**HISTORIC LANDMARK COMMISSION**  
**PERMITS IN NATIONAL REGISTER HISTORIC DISTRICTS**  
**AUGUST 3, 2022**  
**HR-2022-070860**  
**TRAVIS HEIGHTS - FAIRVIEW PARK**  
**407 E. MONROE STREET**

Demolish a ca. 1937 garage apartment and construct a new building.

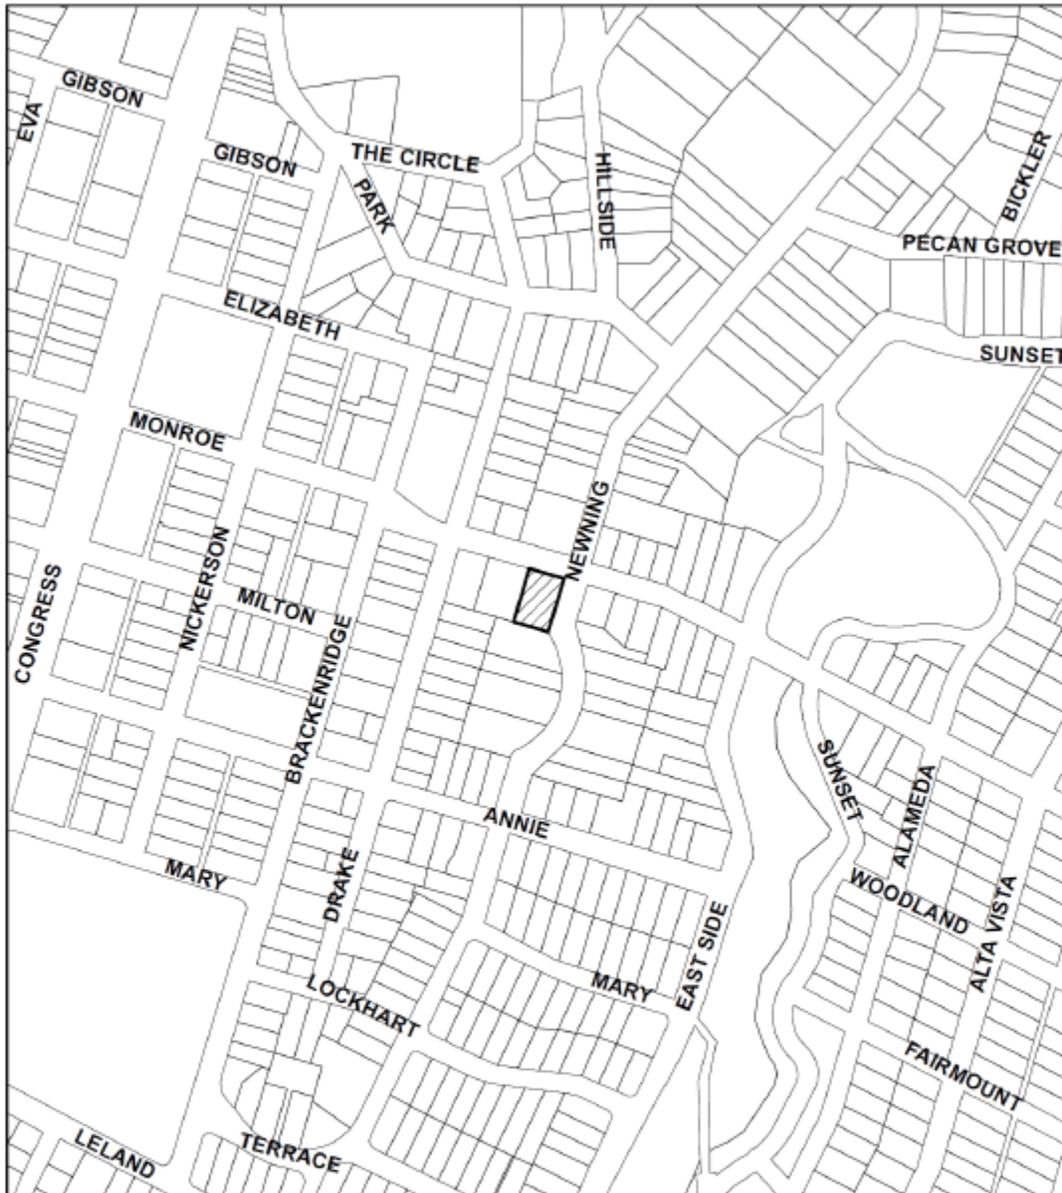
Include divided lights in windows. Implement design changes to reduce building height and increase cohesion with streetscape at roofline and garage.

Release the demolition permit upon completion of a City of Austin Documentation Package. Comment on new construction plans. The applicant has implemented Committee feedback.
